MONTGOMERY COUNTY HISTORIC PRESERVATION COMMISSION
STAFF REPORT

Address:	6700 Needwood Road, Derwood	Meeting Date:	11/13/2024
Resource:	Master Plan Site #22/35 Needwood Mansion	Report Date:	11/6/2024
Applicant:	Montgomery Parks (Eileen Emmett, Agent)	Public Notice:	10/28/2024
Review:	HAWP	Tax Credit:	N/A
Permit No.:	1071486	Staff:	Laura DiPasquale
Proposal:	Building alterations for ADA accessibility improvements, tree removals, and other alterations.

STAFF RECOMMENDATION

Staff recommends that the HPC **approve with two conditions** the HAWP application with final approval delegated to staff:

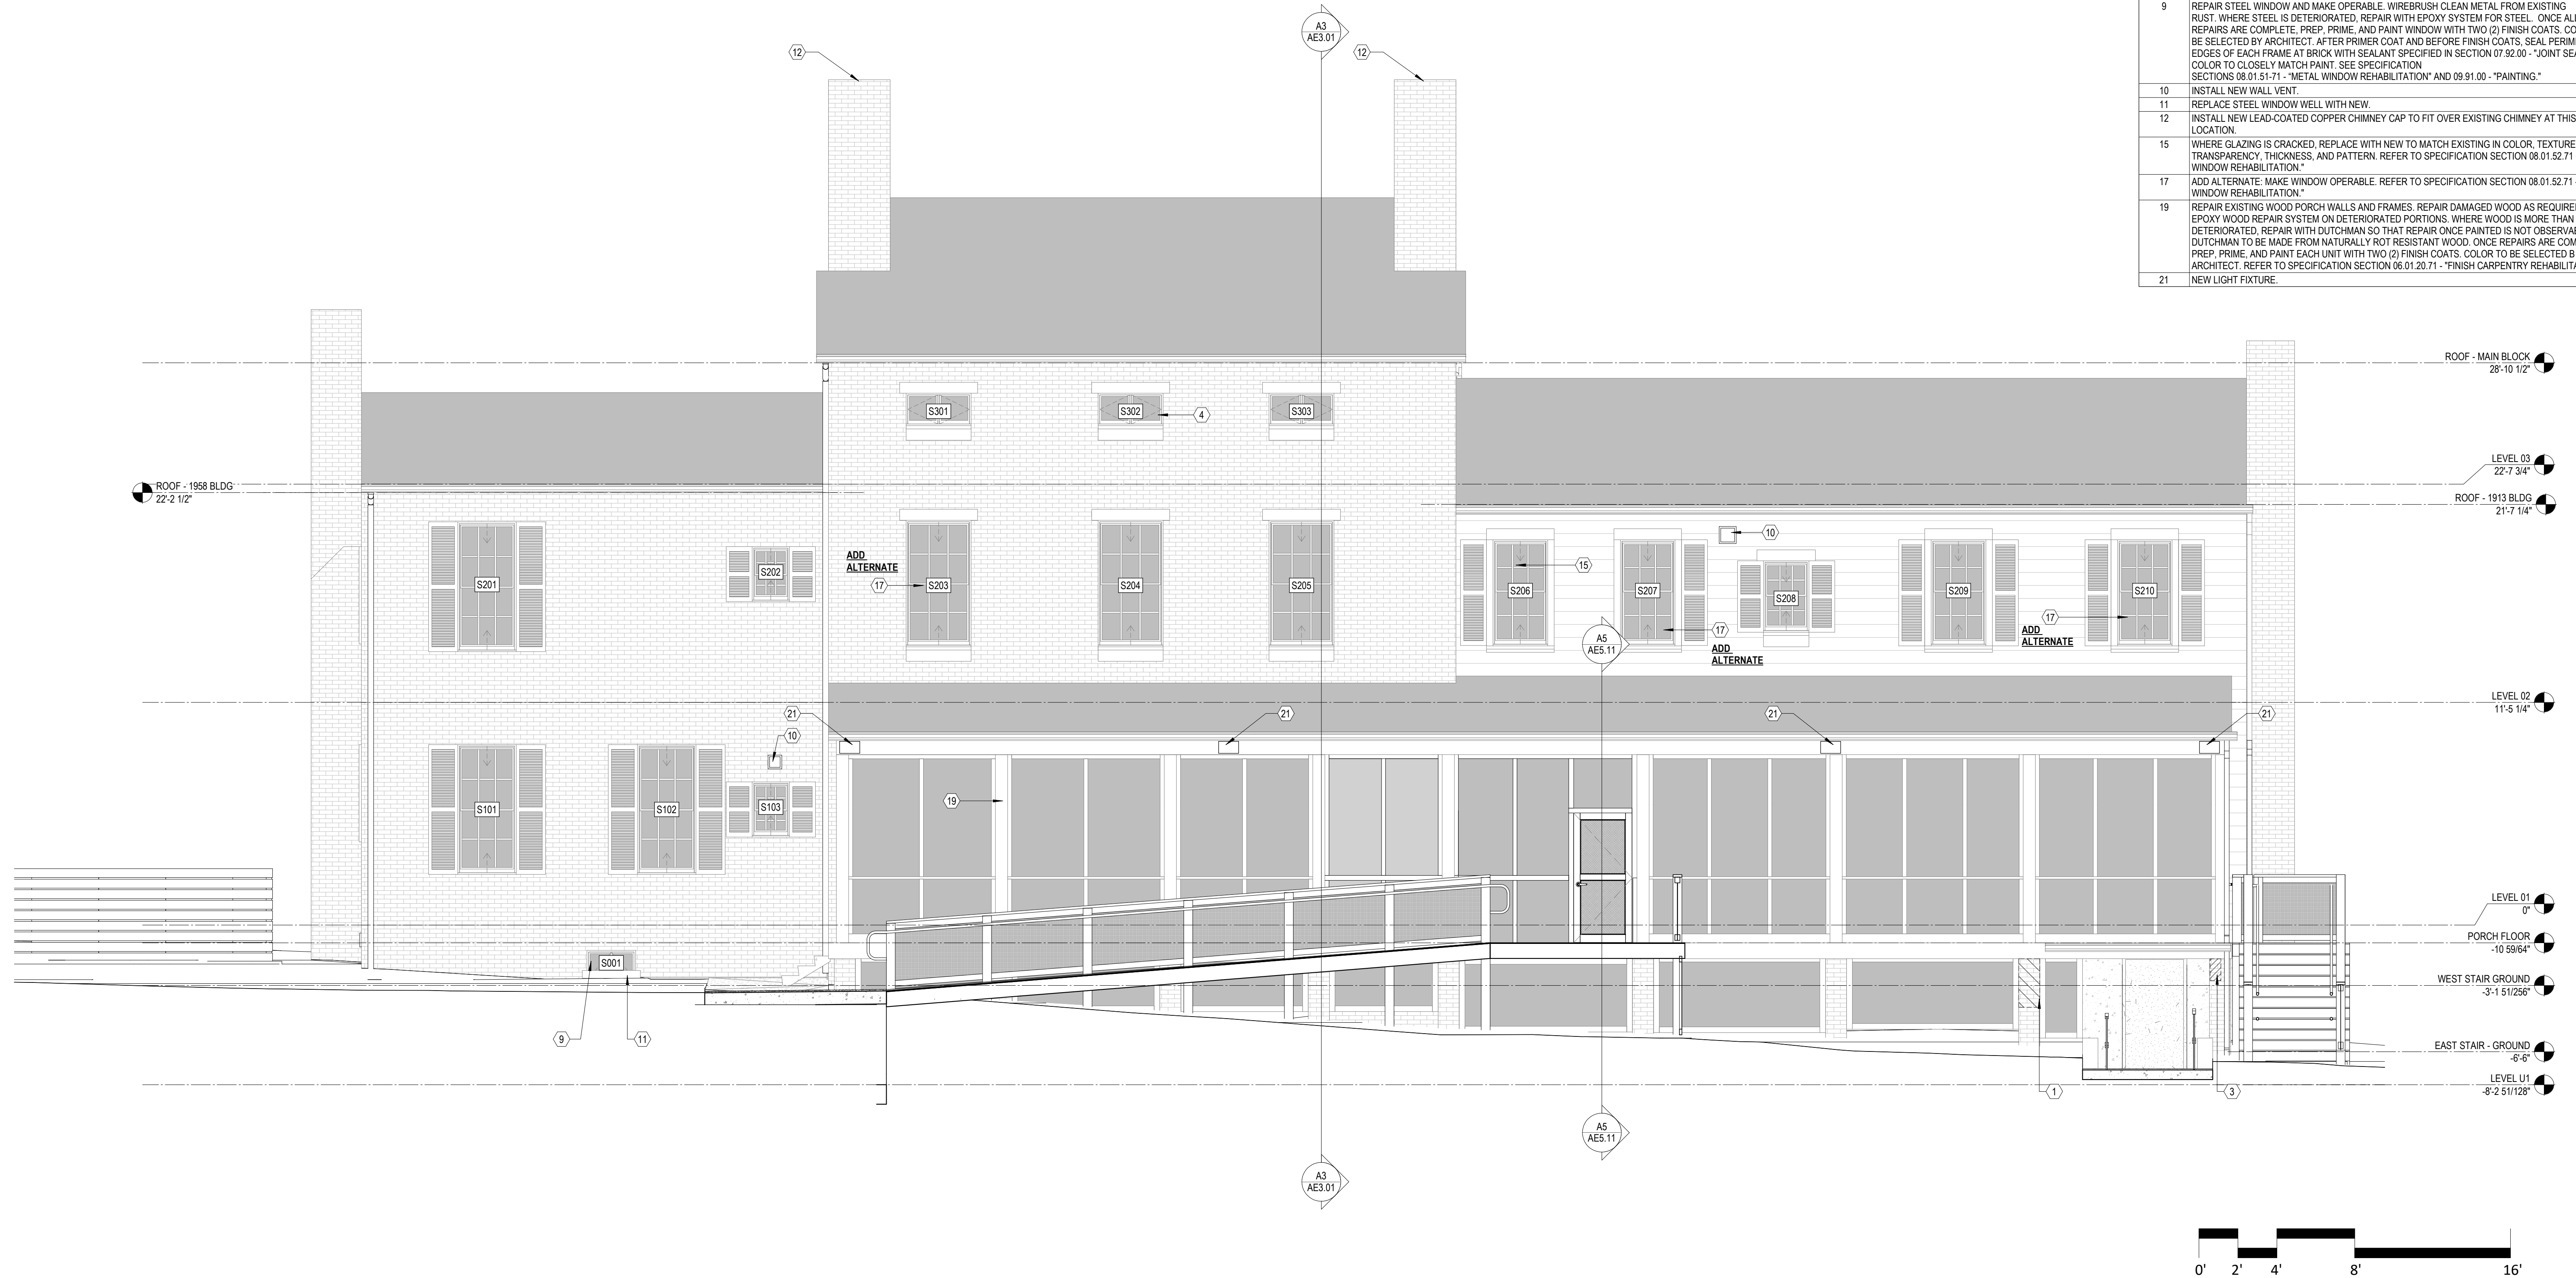
Following the preliminary consultation, the applicant submitted additional drawings showing the proposed ramp in elevation (*Figure 5*, *Figure 13*, *Figure 14*), and an example of the proposed mesh railing and painted wood railing (*Figure 15*). The applicant confirmed by email that the proposed guardrail ramp will be painted a similar green color to the example photographs, because Needwood Mansion has other green accents in the porch lattice and shutters.

Staff supports alterations to the screen porch on the south elevation to accommodate the ADA improvements (Work Items 11, 20, 21, and 22) and finds the work meets both Chapter 24A-8(b) and the applicable *Standards*. The porch is a later alteration to the building, added in the 20th century, and is located on the rear of the building. The modifications are necessary to accommodate the ADA accessibility improvements.

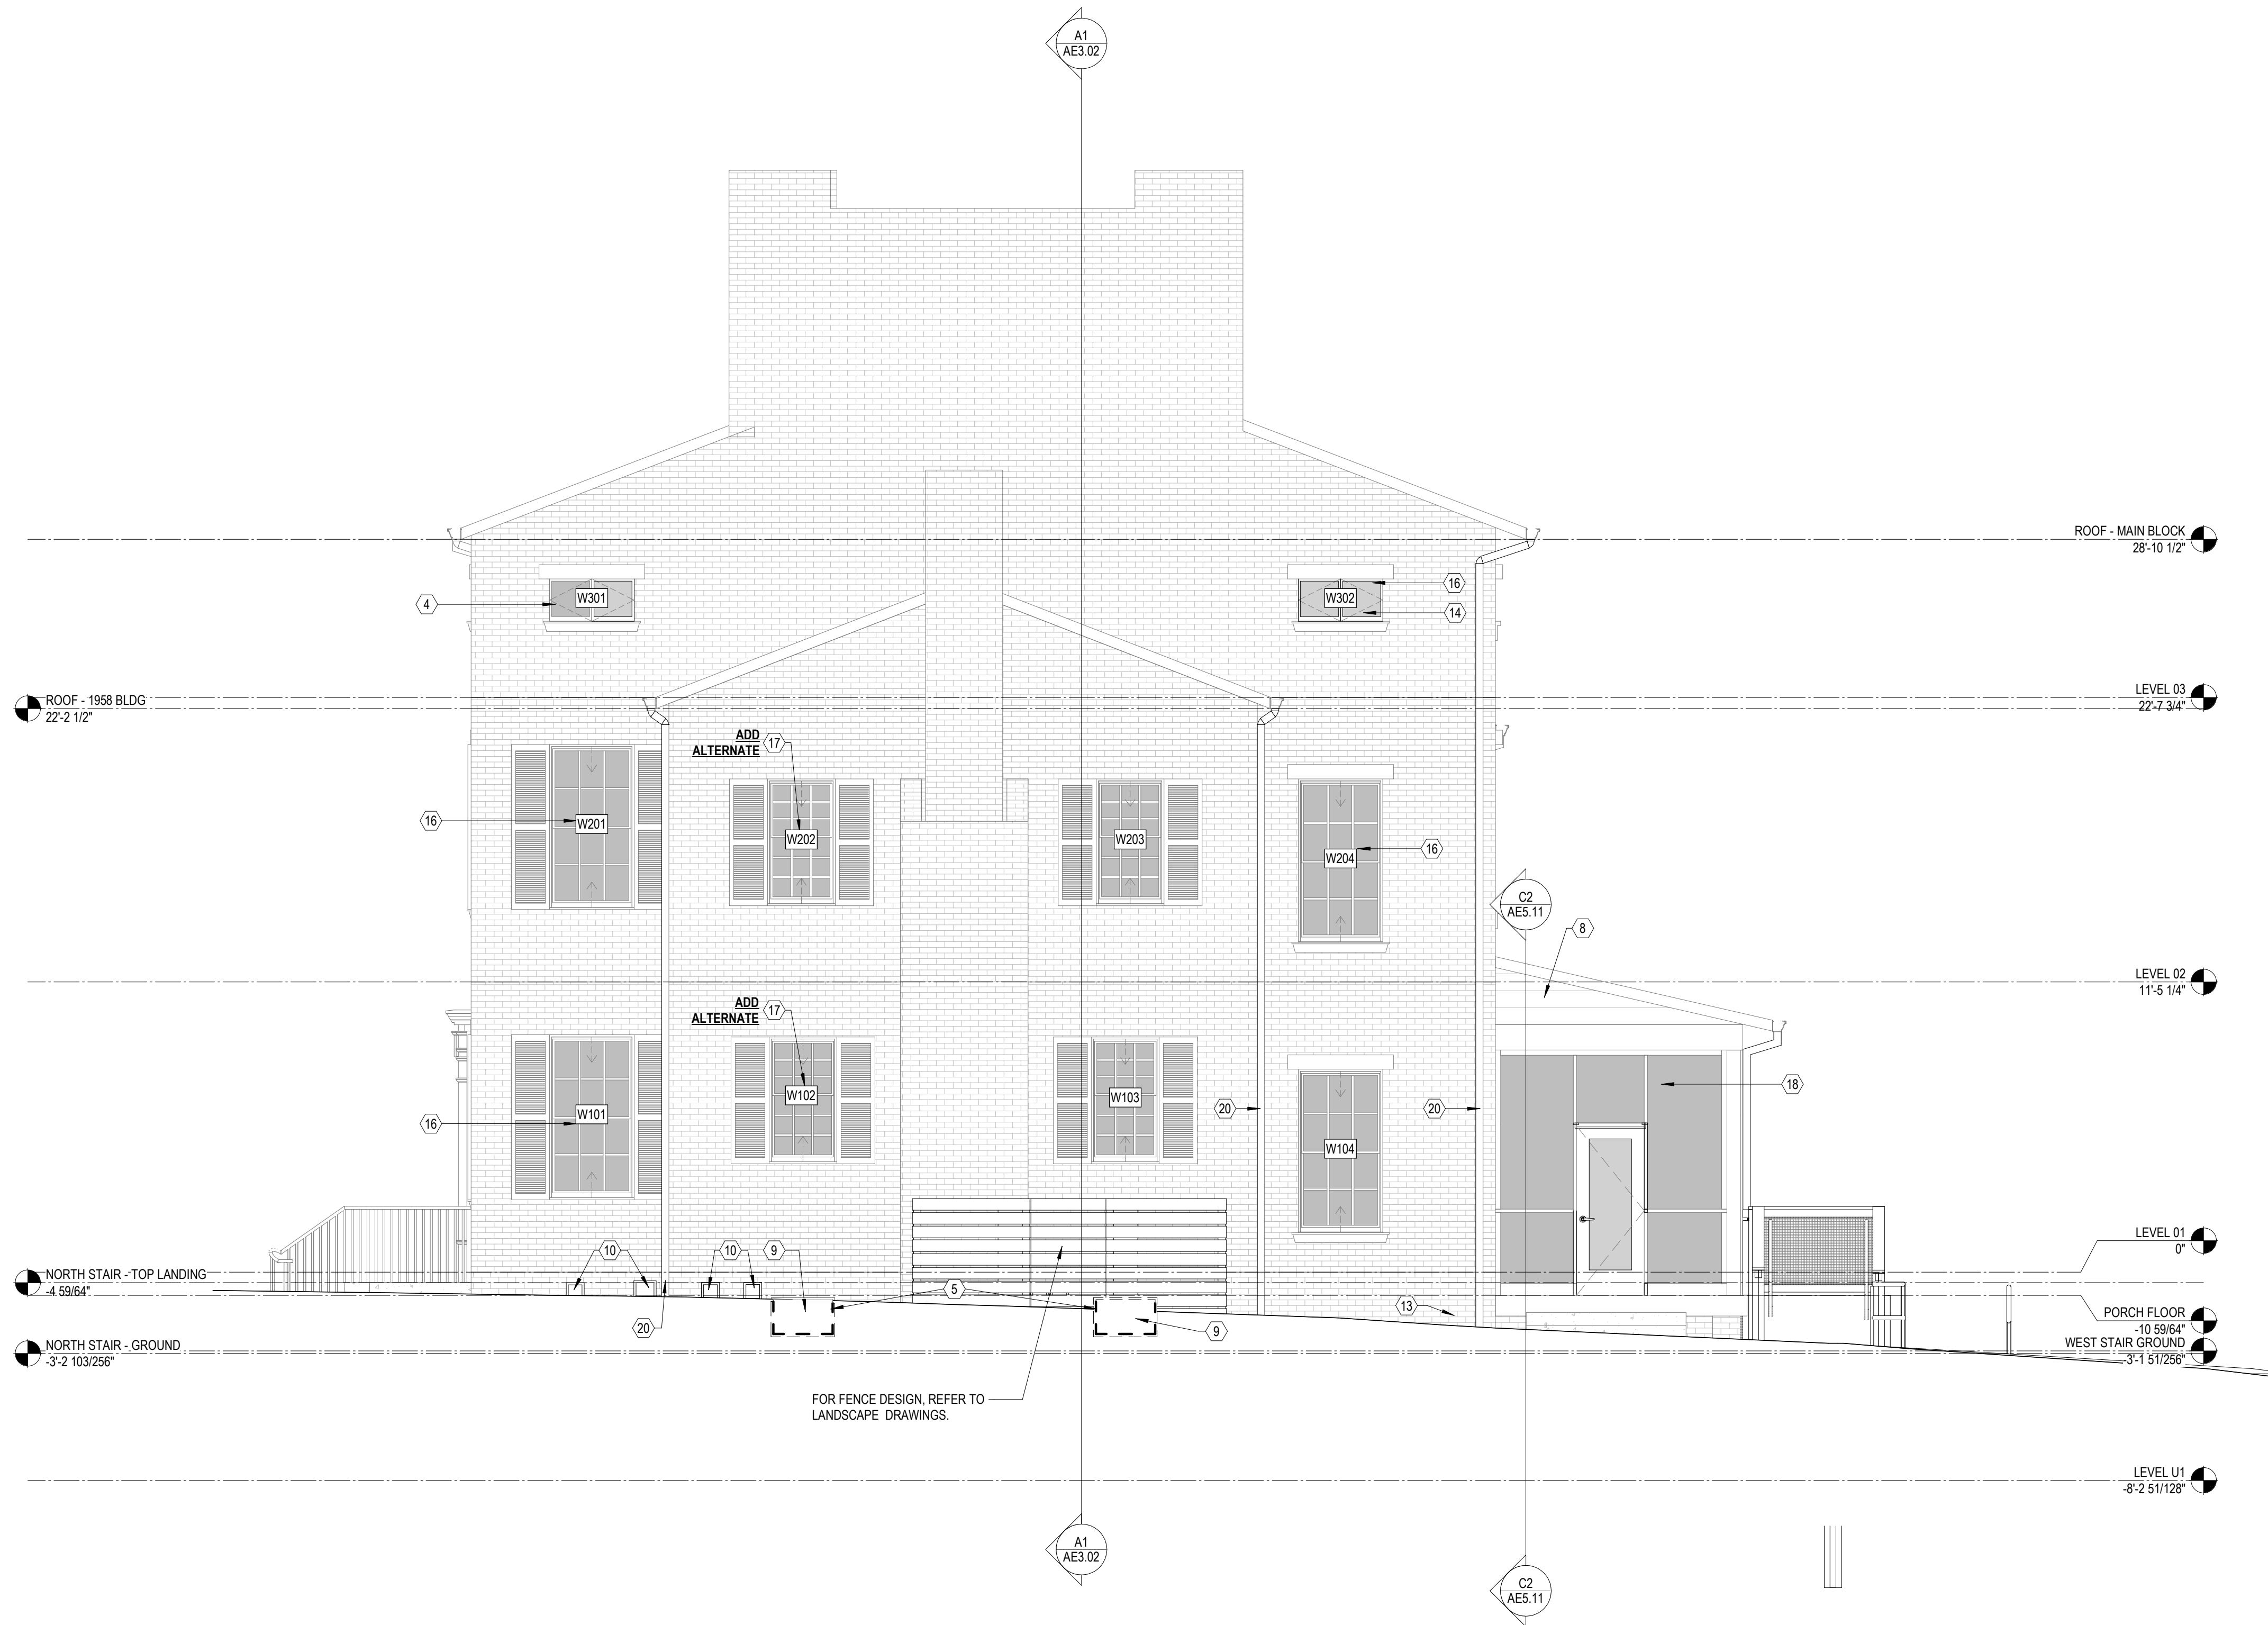
Staff supports the installation of new wood windows at the basement on the front elevation and third floor of the west elevation (Work Items 14 and 15 on *Figure 3* and *Figure 6*, respectively) and finds the work meets both Chapter 24A-8(b) and the applicable *Standards*. The replacement windows are to match the others wood windows found on the corresponding elevations, so they will be compatible to the historic site. Staff recommends that the applicant submit window shop drawings demonstrating that the new window will match the existing windows to staff for final approval.

1. The applicant must submit shop drawings for all new windows and storm windows, including installation details, in elevation, section, and plan.
2. The applicant must submit ADA door hardware specifications.
